REQUEST

Current Zoning: ML-1 (manufacturing & logistics – 1), CG (general commercial), B-2(CD) (general business, conditional), MUDD-O (mixed-use development district, optional)
 Proposed Zoning: MUDD-O (mixed-use development district, optional) and MUDD-O SPA (mixed-use development district, optional, site plan amendment) with 5-years vested rights.

SUMMARY OF PETITION

STAFF RECOMMENDATION

• Proposed Request Details

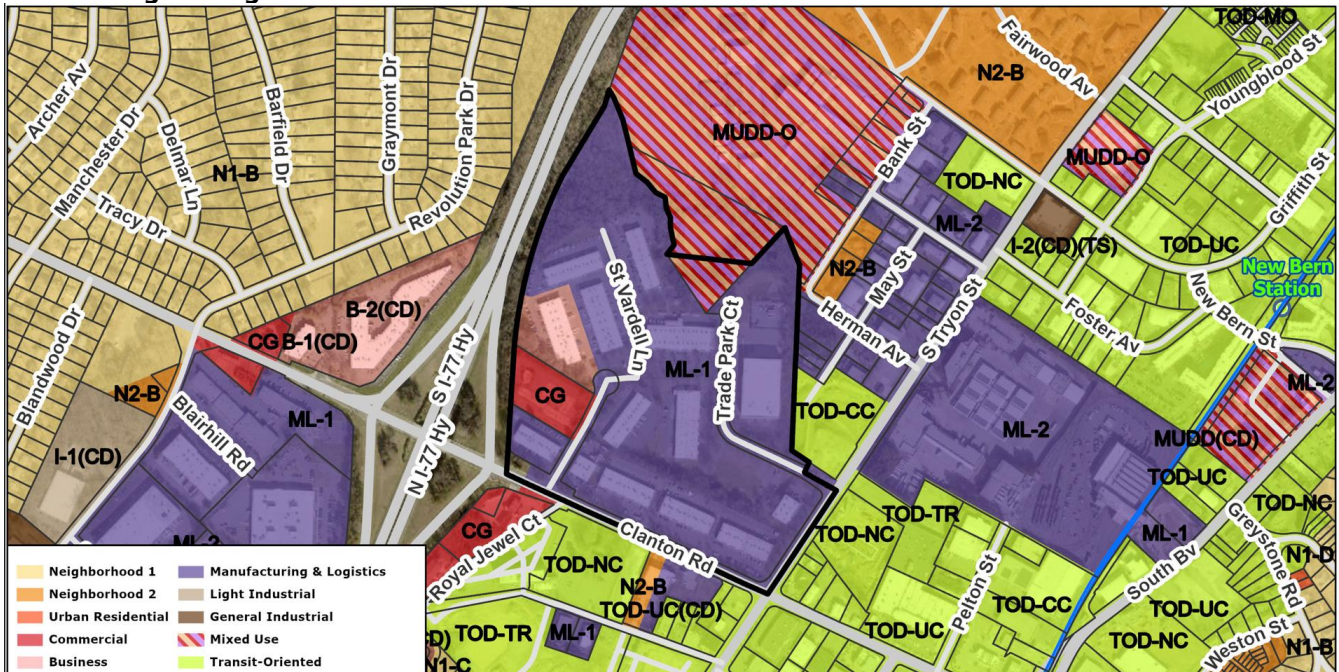
1. ~~Update the TIS with conditional notes regarding mitigation at Clanton Road/I-77 interchange.~~

2. ~~Include a commitment to construct an ADA compliant bus stop along Clanton Road.~~ **Addressed**

3. ~~Increase the specified minimum transparency for upper floors from 15% to 25%.~~ **Addressed**

4. ~~Provide detail on which development area(s) the gas station may be located in and provide a limitation on the number of pumps that would be in the gas station use. Consider adding a commitment to EV charging stations.~~ **Addressed**

5. ~~Revise the design standards for gas stations to commit to a minimum ground floor height for gas stations and orientation of canopies to the rear or side of the street.~~ **Addressed**

6. ~~Revise the minimum ground floor height for multi-family uses to 16 feet rather than all residential uses having a minimum ground floor height of 10 feet.~~ **Modify conditional notes to specify that multi-family uses located along main streets will have a minimum ground floor height of 16' on those block faces.**

7. ~~Revise the design standard notes for drive throughs so that no drive aisle may be located between the building façade and the street, menu boards may not be visible from the street, and note that seat walls that meet screening requirements will be provided to enhance the pedestrian environment.~~

8. ~~Commit to a maximum number of principal uses may have an accessory drive through and provide further limitations on which part of the site may have an accessory drive through, allowing this use on approximately 1/3 of the site is too broad. Staff would support modifying the note to only allow accessory drive throughs in Development Area A2.~~ **Addressed**

9. ~~In note 6 of the optional provisions add the word "reasonable" after the word "allow" in the first sentence.~~ **Addressed**

10. ~~In note 5 of the General Transportation and Streetscape notes add "as approved by CDOT and NCDOT" at the end of the note.~~ **Addressed**

11. ~~Fill in the referenced date of the approved TIS throughout the conditional notes.~~ **Addressed**

12. ~~Clarify note i in the conversion rates notes to detail the maximum number of hotel rooms or residential units that may be created in the conversion of 500 square feet of commercial uses to one hotel room or residential unit.~~ **Addressed**

Addressed

Addressed
